PUBLIC SERVICE COMPANY OF COLORADO

August 13, 1984
Fort St. Vrain
Unit No. 1
P-84275

SUBJECT: Response to NRC/LANL Concerns on
Cracked Fuel Elements

RESPONSE TO NRC/LANL CONCERNS REGARDING
CRACKED FUEL ELEMENT INTEGRITY

FIGURE 1: Typical Dowel/Socket Failure

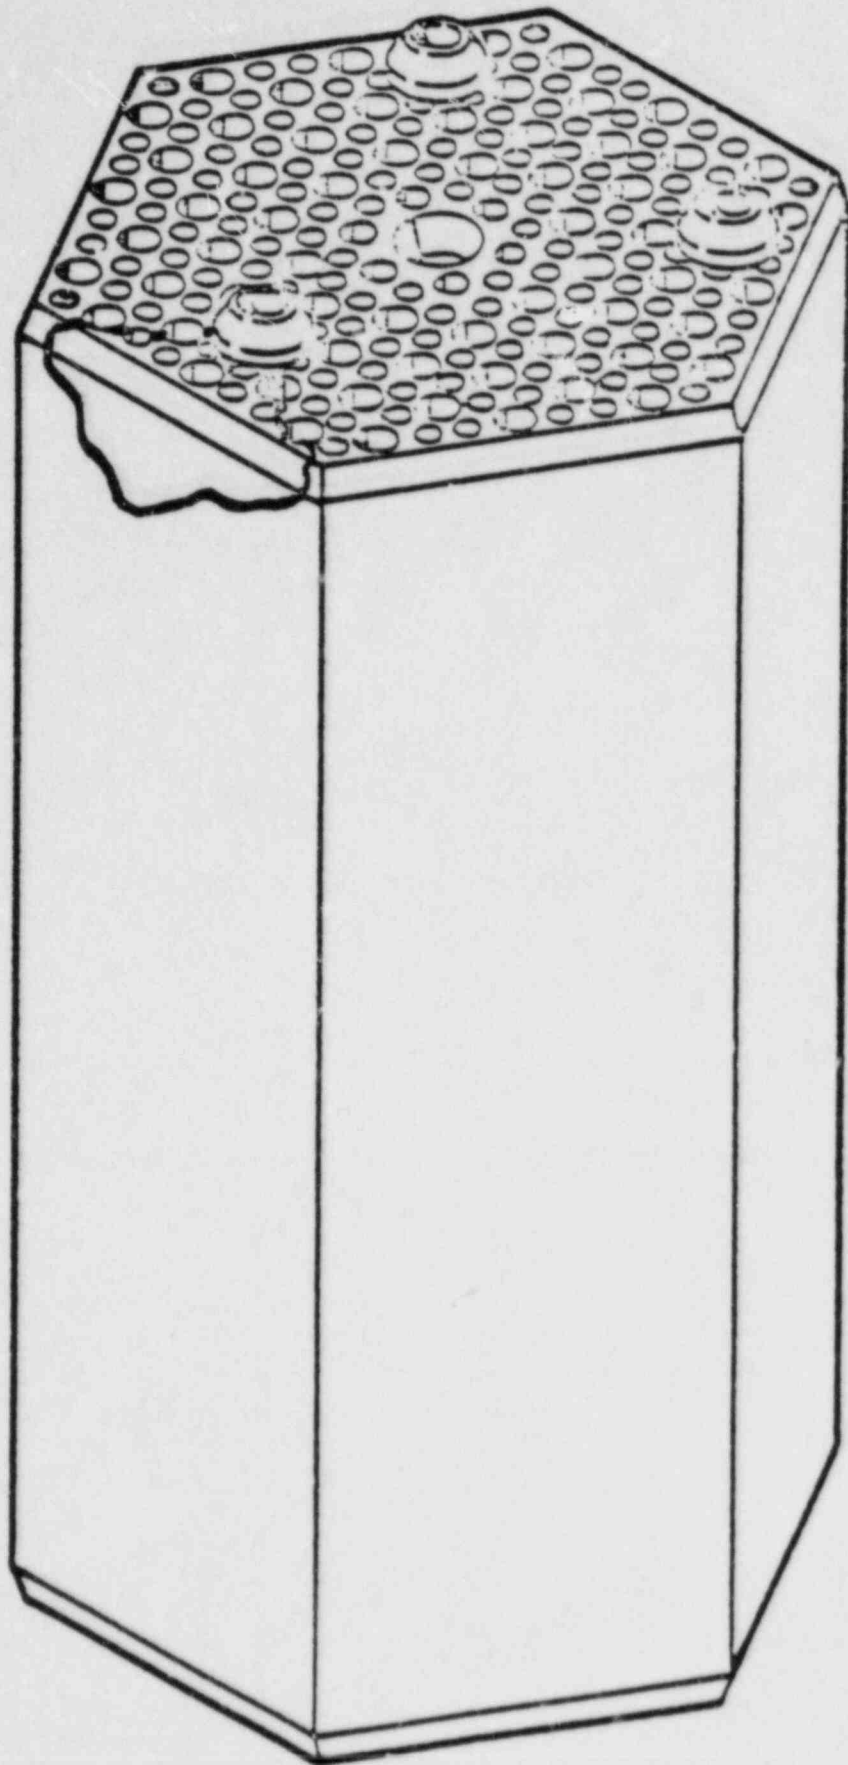
LANL contends that, "during a seismic event the Fort St. Vrain core (as currently constrained by the core restraint devices) will transmit dynamic loads primarily through the dowel pins and socket arrangement located on the ends of the fuel elements. This dynamic load transfer will produce a complex stress field in the interior of the element, and could subsequently cause cracks to further propagate, depending on the magnitude of loads being transmitted."

In fact, the behavior of the fuel elements under dowel-socket system loading is well characterized and has been a subject of previous PSC-NRC correspondence (Ref. 4) related to the core fluctuations investigation. As explained in Reference 4, when the FSV dowel-socket system is loaded to its ultimate capacity, failure occurs in the sidewall of the element between either the socket or the dowel and the nearest face of the fuel element. (See Figure 1.) No failure occurs in the dowel pin itself. This sidewall failure typically initiates as two cracks at the base of the socket or dowel which, under continued application of the load, progress outward to the element edge to encompass a fragment that is about seven inches along the horizontal edge and three inches in the axial direction. Tests on FSV fuel element geometries (Ref. 5) have shown that this failure mode is the same for both static and impact loading conditions, with the dowel-socket system strength being somewhat higher under impact loading.

This failure mode indicates that, rather than being a complex stress field in the interior of the element, the stress field resulting from dowel-socket system loading is (1) a relatively simple stress cone, and (2) relatively localized at the end of the element with regard to stresses of sufficient magnitude to cause graphite failure.

It is possible that the presence of fuel element web cracks such as those seen in the Segment 2 fuel elements in the vicinity of the "B" face dowel might reduce the ultimate capacity of that one (out of three) dowel-socket system. It is unlikely, however, that the resulting localized stress field would produce any notable effect on the crack in the interior of the element. Therefore, extensive crack progression throughout the element is not expected to result from dowel-socket system loading.
